R.e. Response to Councils request for further information

Address: 51 Burns Street, Maryborough

I refer to your request for further information for planning permit application 092-24 and hereby submit our response.

Figure 1: Allocated carparking spaces for Front Commercial Building (CP1 & CP2)

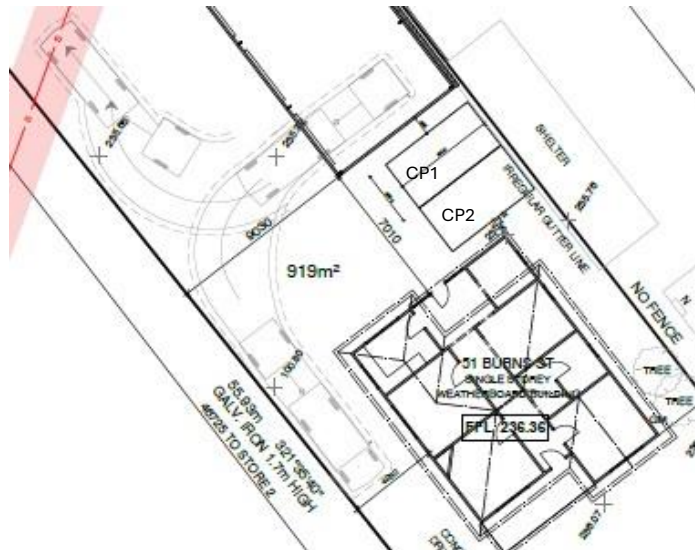
5. An amended response to Clause 52.06 of the Central Goldfields Planning Scheme, including amended plans as necessary. Clause 52.06 requires the following carparking to be provided:

- Store 10% of site area = equivalent of 91sqm of the site (approximately 6 spaces)
- Shop 4 spaces per 100sqm of leasable floor area = 0 spaces
- Office 3.5 spaces per 100sqm of net floor area = 3 spaces

The Planning Report accompanying the application states the 6 spaces for the store use will be contained within the stores themselves, and 2 additional on-site spaces to the rear of the dwelling for those proposed uses.

Given the use of the store by an electrical business it is considered some of the internal car parking will be used by business vehicles. It is noted, however, that this is not a typical outcome and car parking is intended to be separate to a store building.

To assist Council with this consideration, per Clause 52.06-7, a car parking demand assessment must be provided that, in addition to the matters listed in the Clause, considers:

- The number, type and size of vehicles owned/operated by the business.
- The number of anticipated visits to the site by visitors not associated with the business.
- Identification of which store 'bays' are to be used for car parking, including marking on a plan.
- Explanation of how other business materials are to be stored within the stores if all 'bays' are occupied, including marking on a plan.
- Provision of swept paths for all 'bays' to be used for car parking, using a typical vehicle size.

The proposal includes the provision of two (2) new car parking spaces to the rear of the proposed office / shop to be used for the front commercial building.

Building	Carparking Requirement	Carparking calculation	Required parking	Carparking proposed
Shop – 1 room inside front commercial building	4 spaces per 100m <sup>2</sup> leasable floor area	Room Size= 13.32m <sup>2</sup> x 4 / 100	0 car parking spaces	0 spaces proposed
Office & balance of Commercial building area (95.69m <sup>2</sup> in area)	3.5 spaces per 100m <sup>2</sup> floor area	Floor Area: 95.69m <sup>2</sup> x 3.5 / 100	3 carparking spaces	2 spaces to the rear of the commercial building

The front commercial building proposes two (2) onsite carparking spaces to be allocated for its use to the rear of the proposed commercial building. As per Councils comments above, clause 52.06 requires a total of 3 carparks to be provided for the front commercial building so a reduction of 1 carparking spaces has been applied for.
